Revisions and Errata List
AISC Steel Design Guide 37, 1st Printing (Printed and Digital Editions)
February 16, 2023

The following list represents corrections to the first printing of AISC Design Guide 37, *Hybrid Steel Frames with Wood Floors*.

Figure 6-16 should be revised to include the updated dimensions, forces and PNA locations:

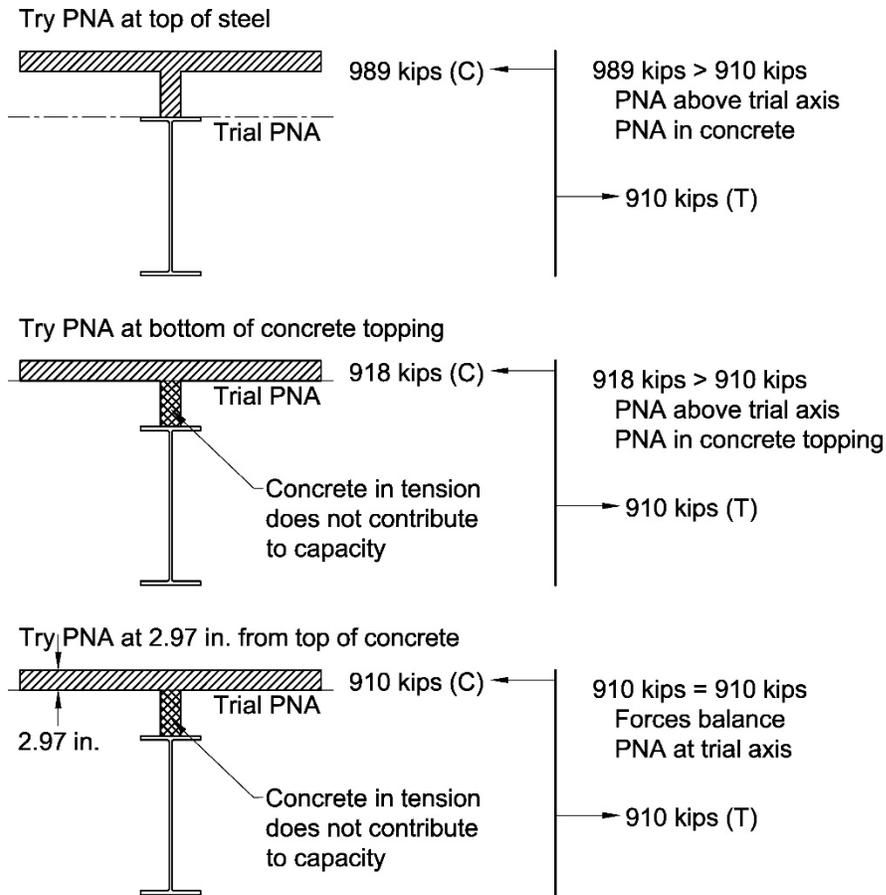
The location of the PNA should be in the concrete
